TRANS/WP.29/GRE/2004/26  
16 July 2004

PROPOSAL FOR DRAFT AMENDMENTS TO REGULATION No. 50

(Position, stop and direction indicator lamps for motorcycles)

Transmitted by the expert from  
the International Motorcycle Manufacturers Association (IMMA)

Maximum and Minimum intensity on the H-H line specified in Regulation No. 50-00, S4

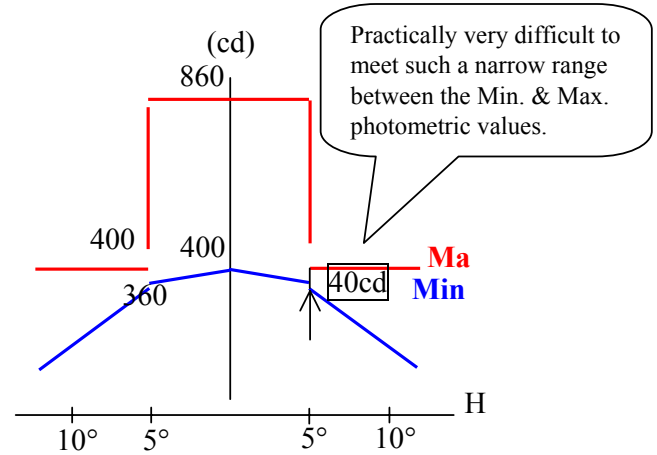
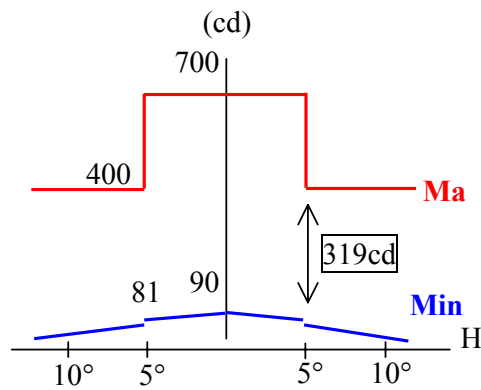
In ECE Regulation No. 50, 00 series of amendments, Supplement 4, new categories 11a, 11b and 11c for the front direction indicator lamps have been provided. These new categories are basically in accordance with ECE Regulation No. 6 (Direction indicator lamps for 4 wheel vehicles), except for the maximum intensities and their zones. Actually, the maximum intensity of 400 cd outside the zone defined by the  $\pm 5$  degrees H and  $\pm 10$ , as shown in footnote 3/ in ECE Regulation No. 50, is not the same as ECE Regulation No. 6, which gives arise to some problems. For example, in category 11c both the minimum value of 360 cd and the maximum value of 400 cd are applied on H-5L and H-5R. The range is only 40 cd, and practically it is very difficult to meet such a narrow range of the photometric values.

\*3 However, the intensity of the light emitted outside the zone defined by the  $\pm 5$  degrees H and  $\pm 10$  degrees V shall not exceed 400 cd

- (1) delete the maximum intensity of 400 cd to outside of the zone defined by the  $\pm 5$  degrees H and  $\pm 10$  degrees V.
- (2) provide the new maximum intensity requirement to the outside of the zone defined by the  $\pm 10$  degree H and  $\pm 10$  degree V (10 degrees-field).
- (3) Between the boundaries of the 10 degrees-field and the 5 degrees-field ( $\pm 5$  degrees H and  $\pm 5$  degrees V), the maximum values are increased linearly up to 700 cd.

- (1) delete the maximum intensity of 400cd to outside of the zone defined by the  $\pm 5$  degrees H and  $\pm 10$  degrees V.
- (2) provide the new maximum intensity requirement to the outside of the zone defined by the  $\pm 15$  degree H and  $\pm 15$  degree V (15 degrees-field).
- (3) Between the boundaries of the 15 degrees-field and the 5 degrees-field ( $\pm 5$  degrees H and  $\pm 5$  degrees V), the maximum values are increased linearly up to 800 cd (category 11b) or 860 cd (category 11c).
